# Work Order ID 92777

Item Name: 205 Skidtube bent detail

DRAWING NO. D2580	TITLE 205 SKIDTUBE ASSEMBLY	REV. E	DART AEROSPACE LTD ENGINEERING ORDER		D.E.O. NO. D2580-E-1	SHEET NO. SHEET 1 OF 1	SCALE NTS
DRAWN <i>DP</i>	CHECKED <i>ASS</i>	MFG. APPR. <i>ER</i>	APPROVED <i>#</i>		DE APPR. <i>#</i>		
DATE 11.12.13	DATE 11.12.13	DATE 11.12.13	DATE 11.12.13		DATE 11.12.13

CHANGE ALL C'BORED WELDED CROSSBOLT SPACERS TO SWAGED SPACERS

SECTION B-B, F-F, I-I  
NOT TO SCALE

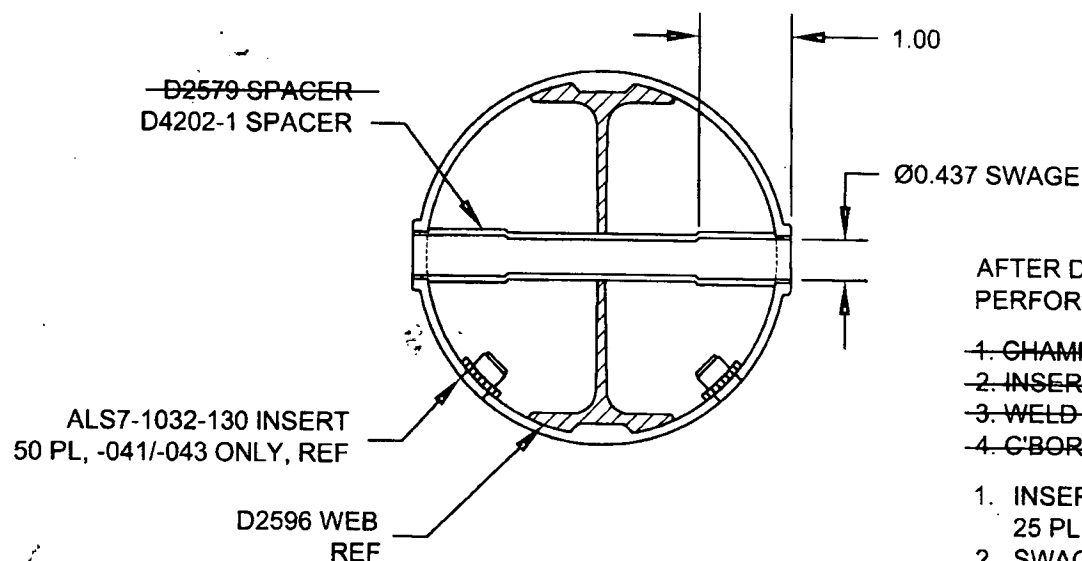
SECTION B-B, SECTION F-F, & SECTION I-I ARE AMENDED AS FOLLOWS  
FOR ALL HOLES THAT WERE ORIGINALLY C'BORED:

1. CHAMFER HOLE 0.060 X 45°
2. INSERT D2579 SPACER (20 PLACES)
3. WELD INTO PLACE AND GRIND FLUSH
4. C'BORE D2579 SPACER TO Ø0.437 X 1.00 DEEP

4		* D2579	CROSS BOLT SPACER
20	20	25	D4202-1	SPACER

WELD 4X D2579 SPACERS PER DWG  
IN LOCATIONS MARKED "NO C'BORE".  
REF SHEET 4 OF DWG.

1. INSERT D4202-1 SPACER, 20 PL (-041) OR 20 PL (-045) OR 25 PL (-047)
2. SWAGE TO Ø0.437 X 1.00 DEEP PER QSI 002
3. TRIM / GRIND FLUSH PER QSI 002
